# CITY OF ALBUQUERQUE

PLANNING DEPARTMENT – Development Review Services

**RE: Sunset Gardens Subdivision (File: K12D003)**  
**Drainage Report, Engineer's Stamp Date 1-19-15**  
**Grading and Drainage Plan, Engineer's Stamp Date 8-20-15**

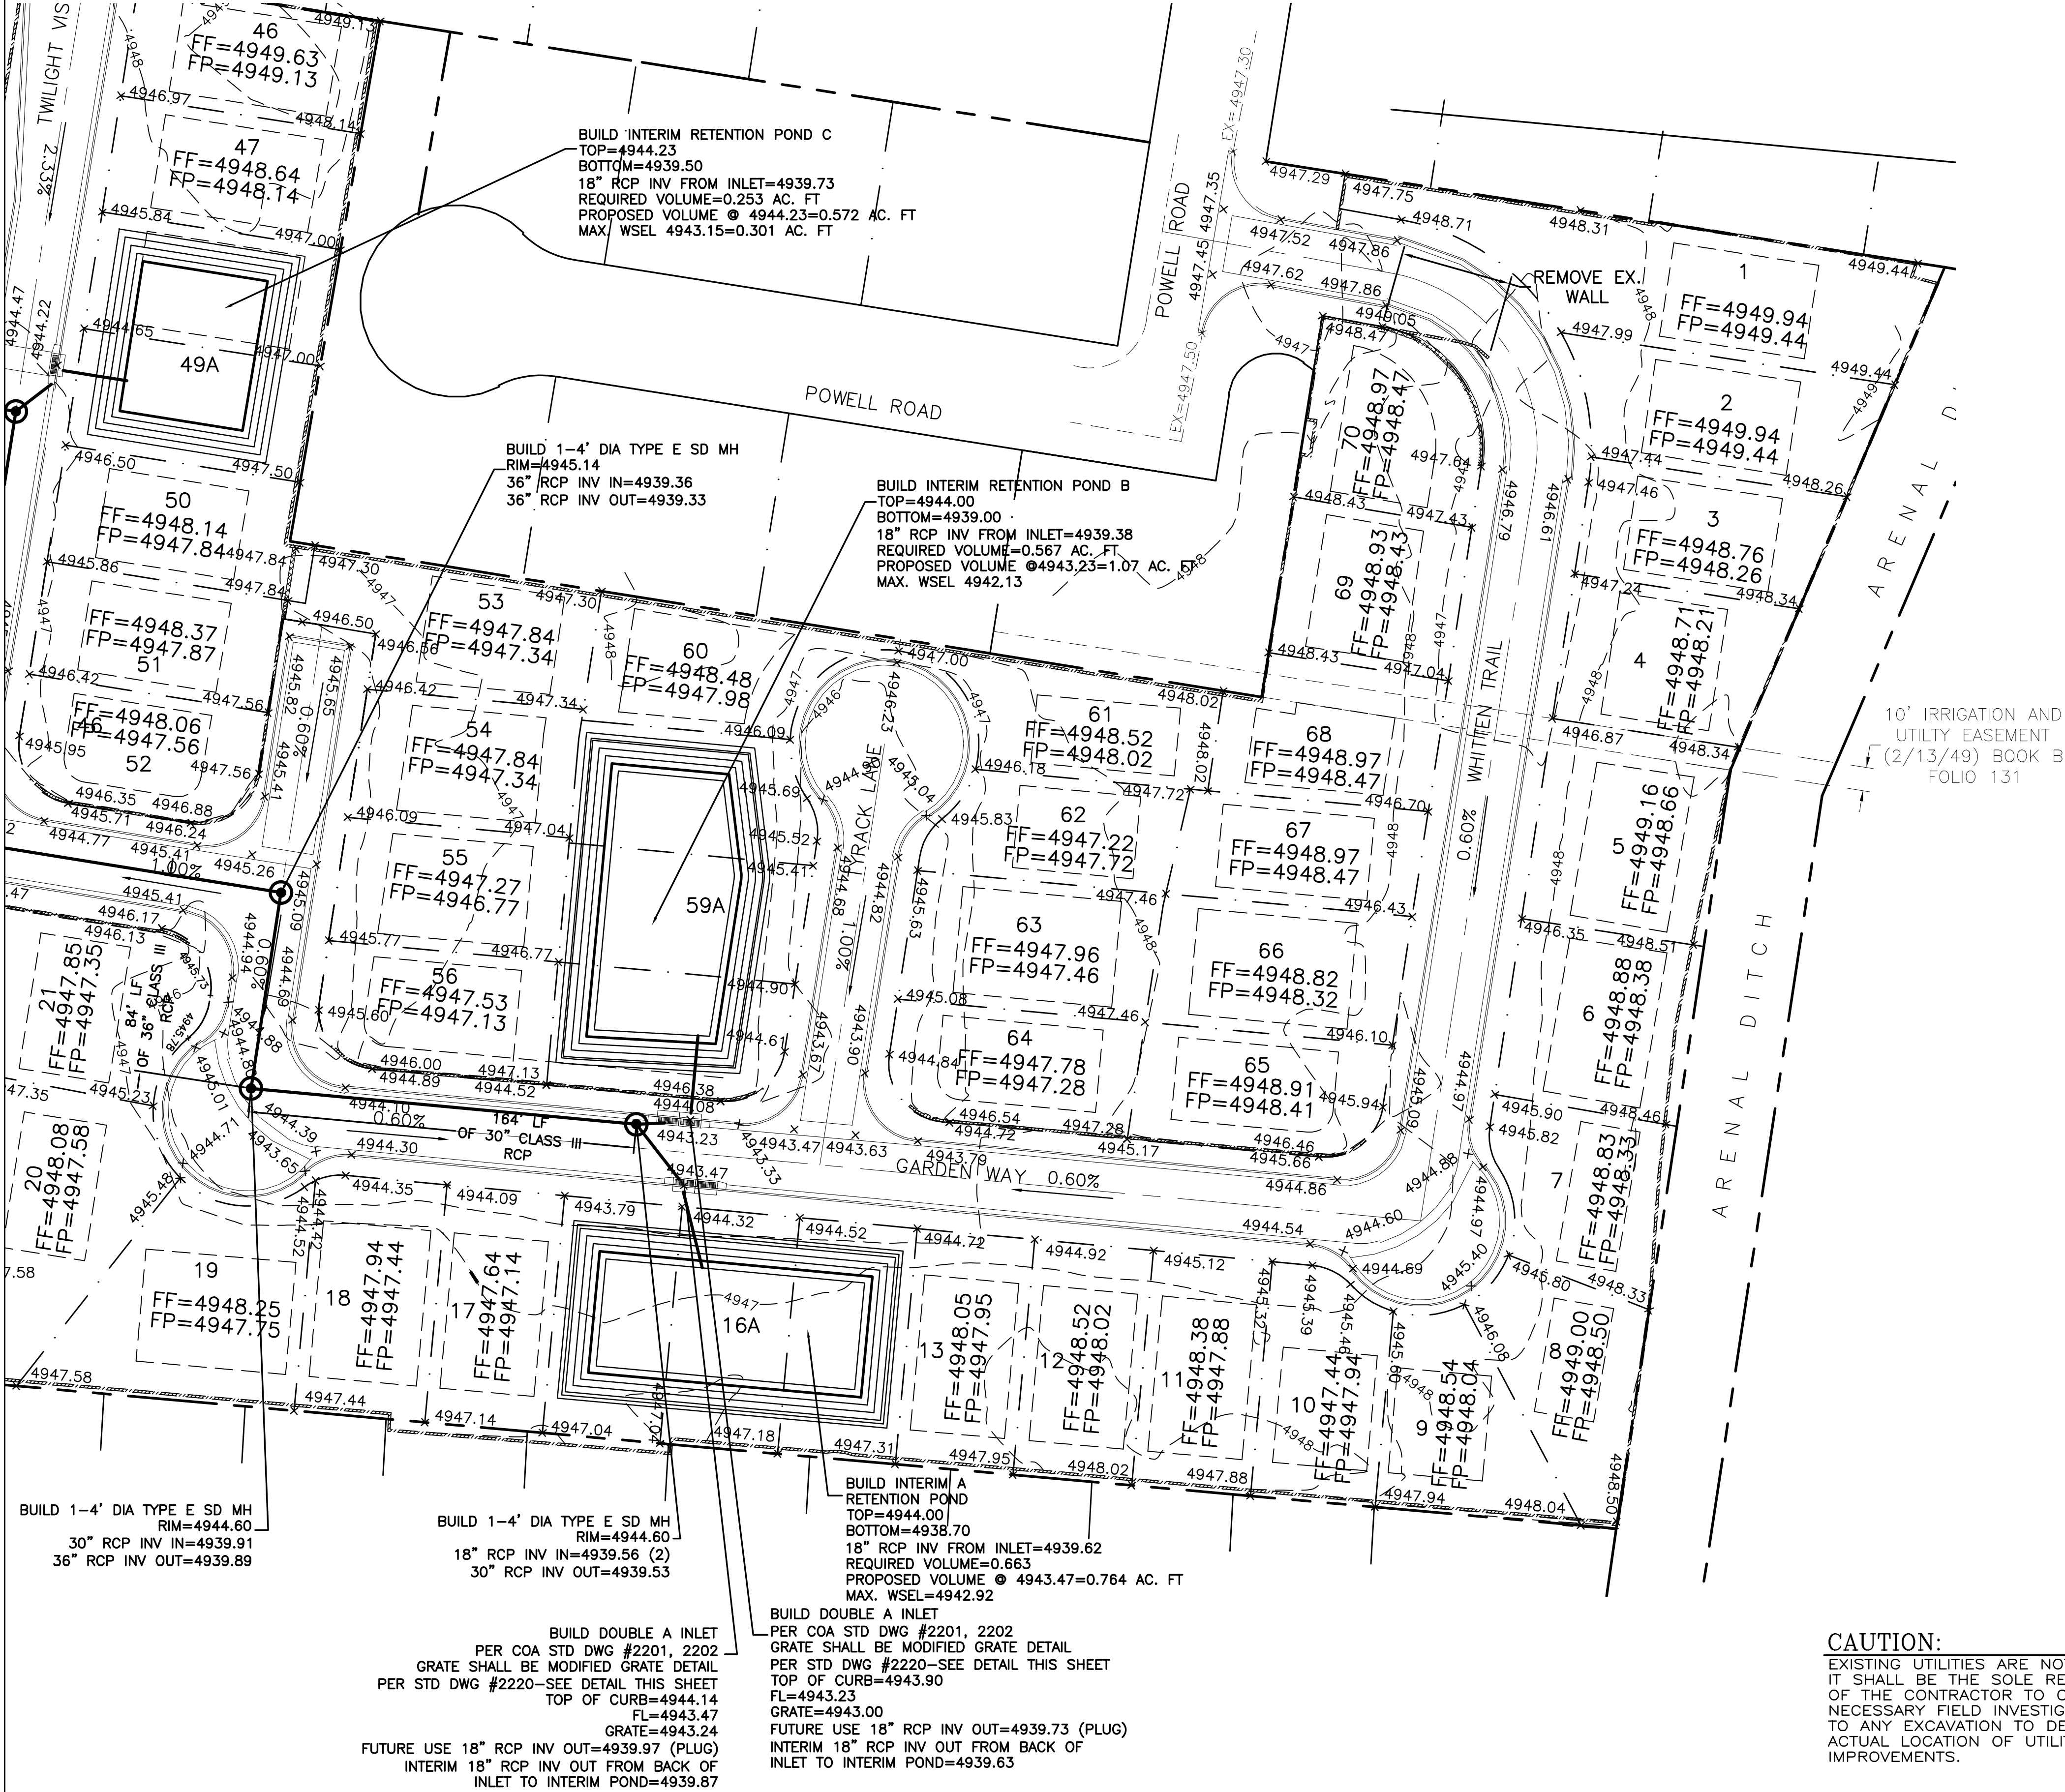
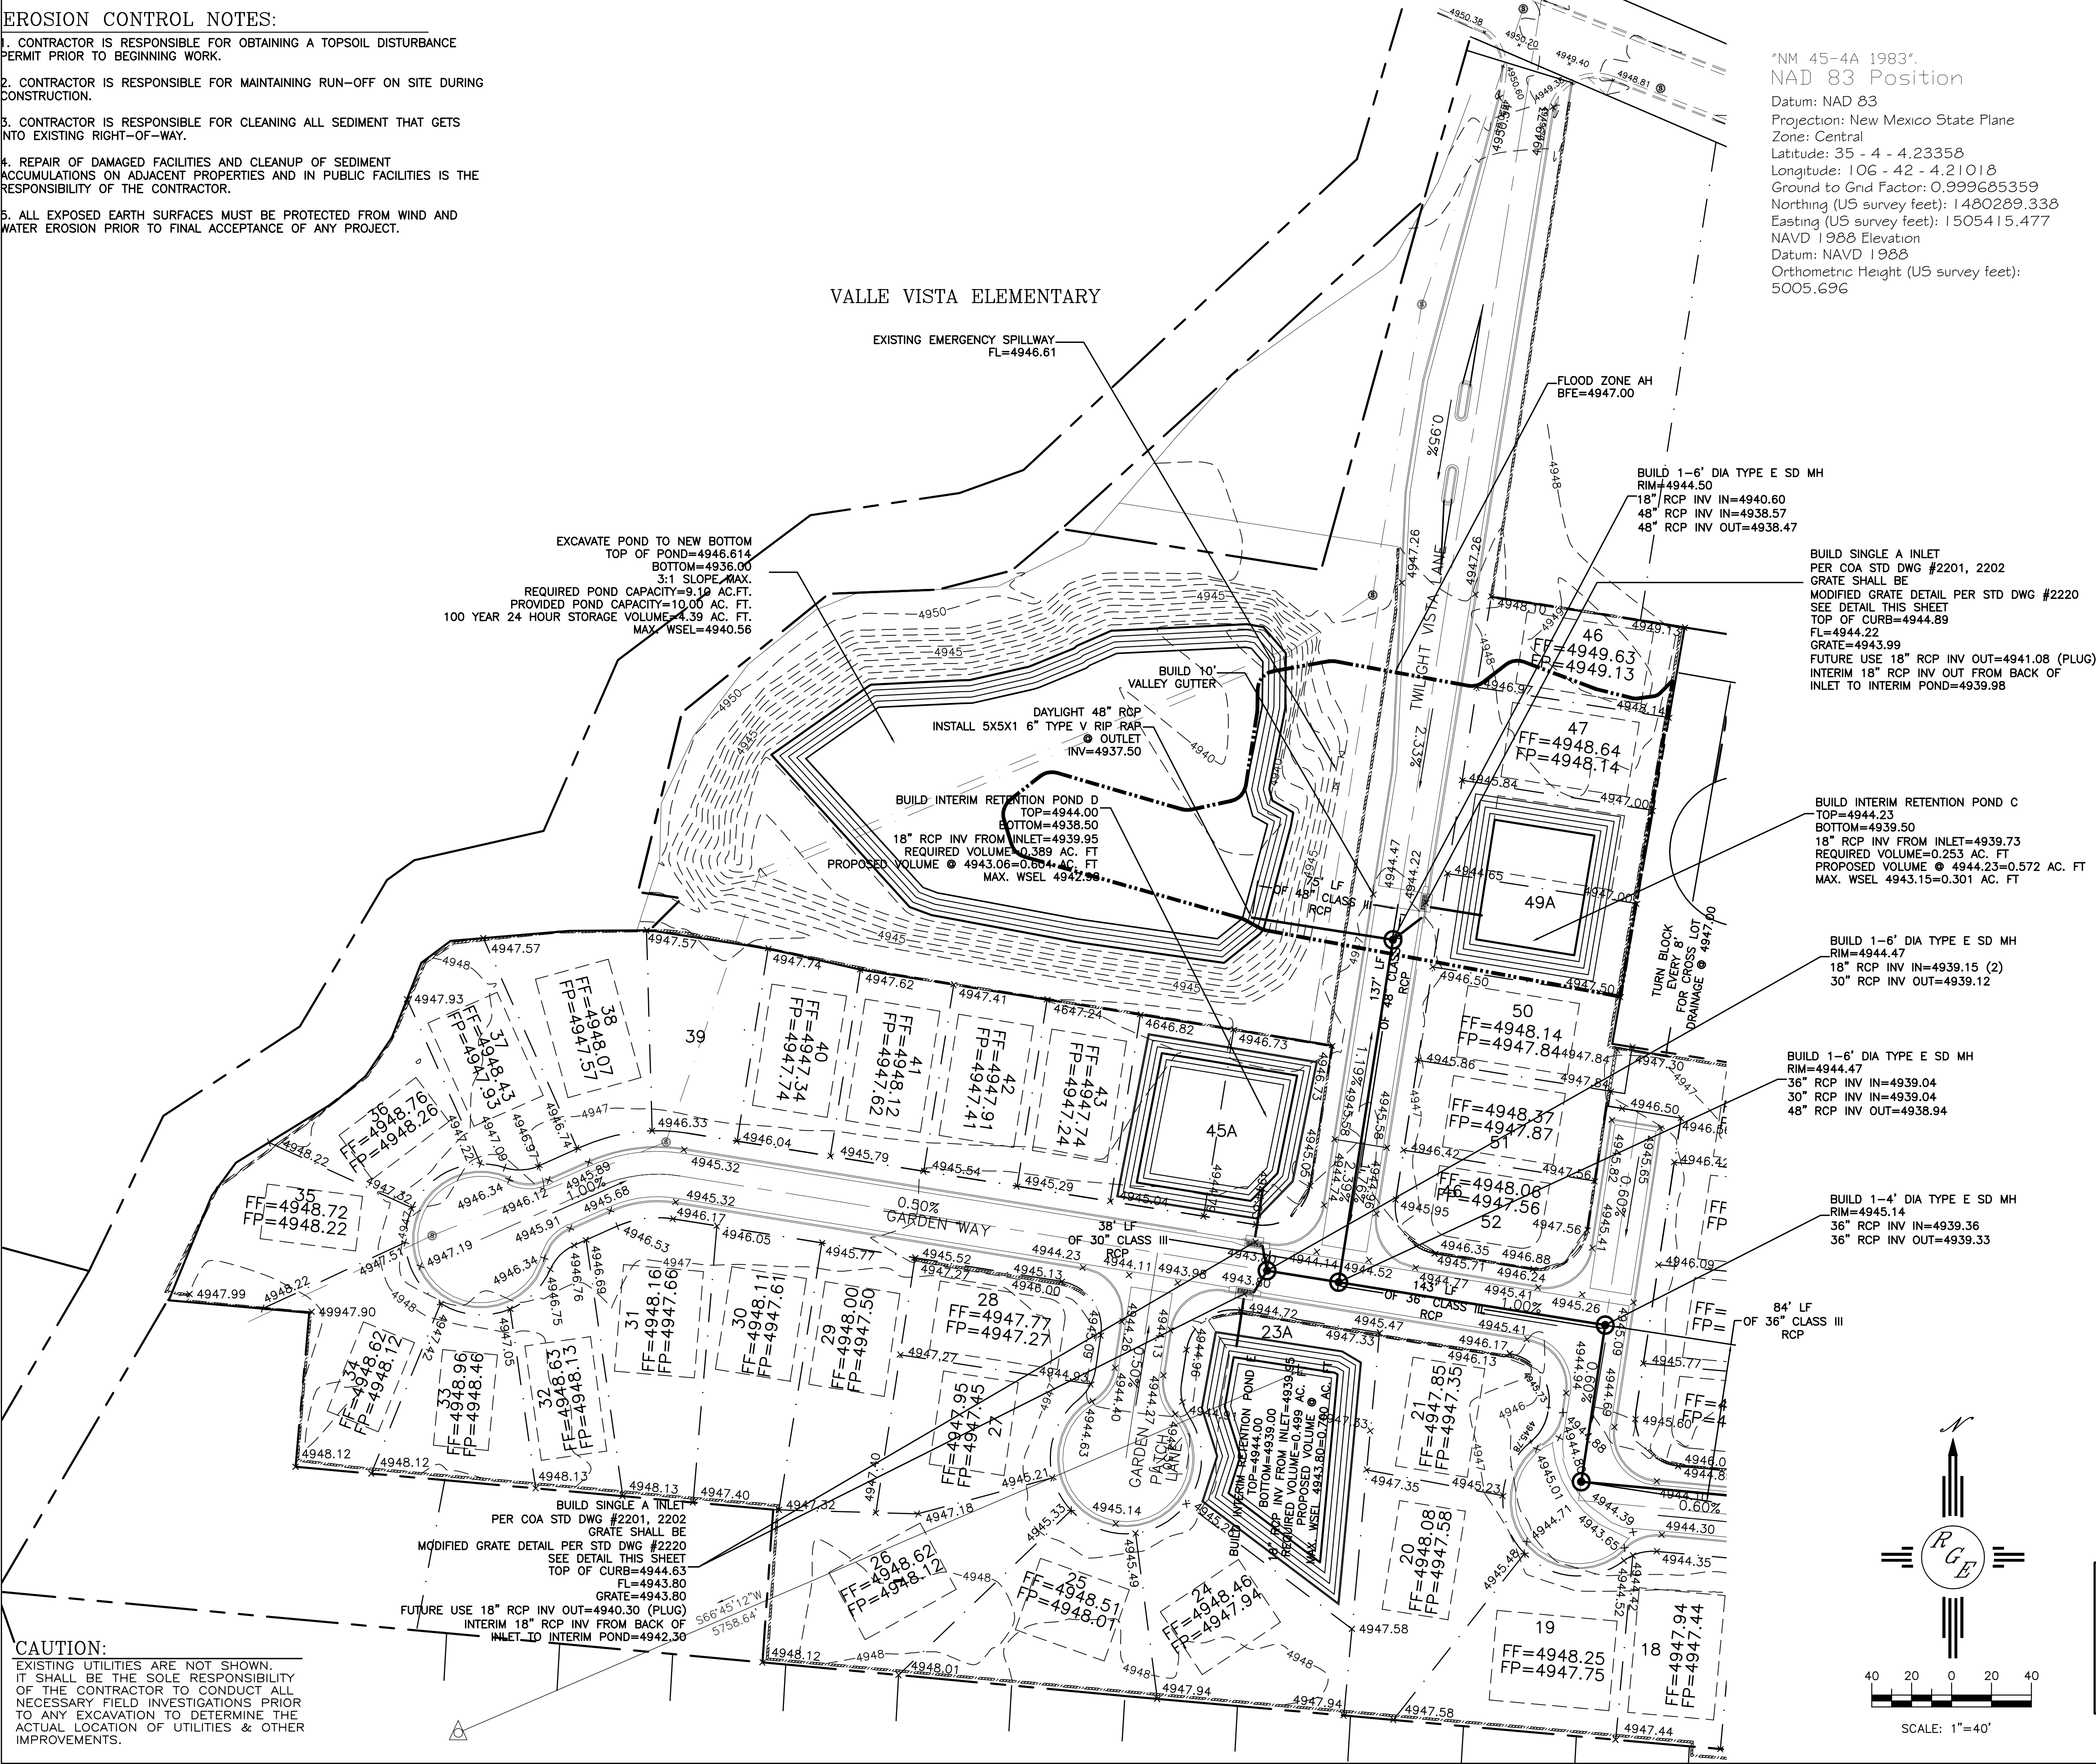
- 1) It is noted that this project was originally designed and approved by others, and the site has already been rough graded. The pad elevations are intended to remain the same as the original design. However, the road design changed and is sloped to allow for surface drainage. As a result Lot 13 (and other lots) has a pad that is high relative to the road resulting in a drive pad with a 16% slope. Pad elevations need to be adjusted such that the drivepad is at a maximum of 15% slope. This should be reflected both on the Work Order Construction set and the Engineer's Certified plan .
- 2) A LOMR-F is required prior to Building Permit for lots 46 and 47

1. Show removal of the Existing wall in the roadway near Powell
2. Roadway tract needs a paper drainage easement prior to DRC
3. Obtain a Flood plain permit for construction in the flood zone prior to DRC
4. Provide inlet detail. Show how the bottom is to slope for the interim condition, and how it is intended to be modified for the future condition. (The inverts into pond are lower than the "future use inverts." When the inverts to the pond are plugged in the future, lean fill can be poured to slope the bottom of the inlet to the "future use" invert. )
5. Adjust the Flowline El. And T.O.Curb Elev. at inlet discharging to Pond E. F.L and Grate are shown at same elev. and grate cannot be lowered as it is already at the MAX WSEL of Pond E.
6. Correct the "INLET TO INTERIM POND =4942.30" for inlets discharging to Ponds D and E. Invert should be less than the "FUTURE USE INVERT OUT=40.30"
